# Access Compliance Report

## Public Rights-of-Way

### (Pedestrian Signals)

Intersection ID: N/A	Main Street:	Cross Street: N/A	Location: N/A
ADA ID: 497E8E5CD3A4	Signal Type: One Push Button-Non APS	Overall Compliance: No	Severity Score: BTN 1: N/A BTN 2: N/A No BTN: N/A
Codes/Mitigation Info/Possible Solution		Field Measurements/Component Compliance

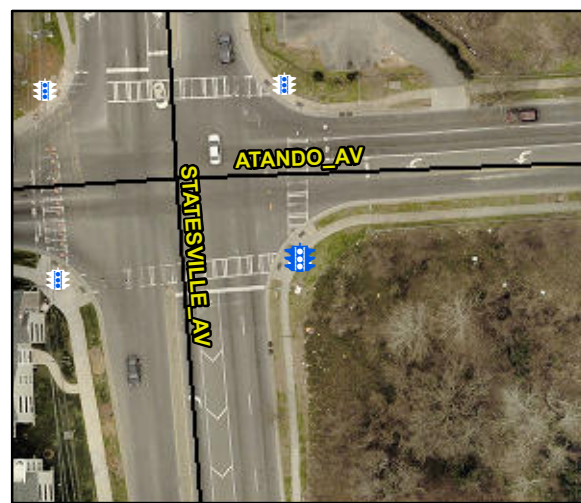
Yes	B 1 Clear Xing Direction?	ClearlyMarked	N/A	B 2 Clear Xing Direction?	N/A
	B 1 Crossing Direction	To SW		B 2 Crossing Direction	N/A
Yes	B 1 DistanceTo XWalk (in)	0.0	N/A	B 2 DistanceTo XWalk (in)	N/A
No	B 1 DistanceTo Curb (in)	134.0	N/A	B 2 DistanceTo Curb (in)	N/A
Yes	B 1 Diameter (in)	2.0	N/A	B 2 Diameter (in)	N/A

Possible Solutions: Replace Signal Push Button With APS Button on New Post. Remove & Relocate Sign.

PROW/ADA: R209.1, TMUTCD 4e.08, R404.3, R404.2, R406.2
